# Access Compliance Report

## Public Rights-of-Way

### (Curb Ramps)

Intersection ID: 50735	Main Street: JONES RIDGE DR	Cross Street: OLD PROVIDENCE RD	Location: W
ADA ID: CCEEDC18F356	Ramp Type: PerpDiag	Initial Pass/Fail: Fail	Overall Compliance: No
Severity Score: 13.75			
Codes/Mitigation Info/Possible Solution		Field Measurements/Component Compliance

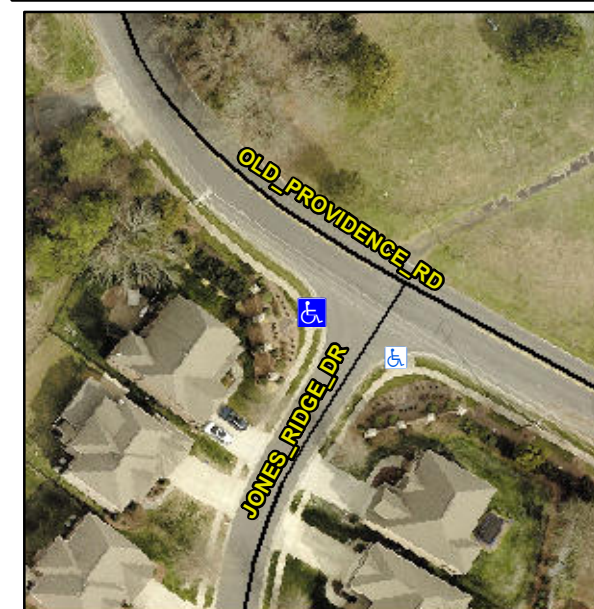
**Not Found, R304.2.2, R304.5.3**

Compliance	Description	Data	Compliance	Description	Data
N/A	Ramp Length (in)	53.5	No	Ramp Slope (%)	11.0
Yes	Ramp Width (in)	48.0	No	Ramp XSlope (%)	3.3
N/A	Flare Type LT	N/A	N/A	Flare Type RT	N/A
N/A	Flare Slope LT (%)	N/A	N/A	Flare Slope RT (%)	N/A
N/A	Flare Traversable LT?	N/A	N/A	Flare Traversable RT?	N/A
N/A	Landing Length (in)	N/A	N/A	DWS Provided?	N/A
N/A	Landing Width (in)	N/A	N/A	DWS Contrast?	N/A
N/A	Landing Slope (%)	N/A	N/A	DWS Length (in)	N/A
N/A	Landing X Slope (%)	N/A	N/A	DWS Full Width?	N/A
N/A	Landing Curb? (Y/N)	N/A	N/A	DWS Offset (in)	N/A
N/A	Shared Landing?	N/A			
N/A	Gutter Ponding?	N/A	N/A	Gutter Slope (%)	N/A
N/A	Gutter Lip Ht (in)	N/A	N/A	Gutter X Slope (%)	N/A
N/A	Painted X Walk1?	No	N/A	Painted X Walk2?	No
	X Walk 1 Direction	To SE		X Walk 2 Direction	To NE
N/A	X Walk 1 Width (in)	N/A	N/A	X Walk 2 Width (in)	N/A
	X Walk 1 Slope (%)	2.5		X Walk 2 Slope (%)	1.5
	X Walk 1 X Slope (%)	1.9		X Walk 2 X Slope (%)	3.0

**Remove & Replace Curb Ramp With Two New Directional Ramps or Equivalent.**
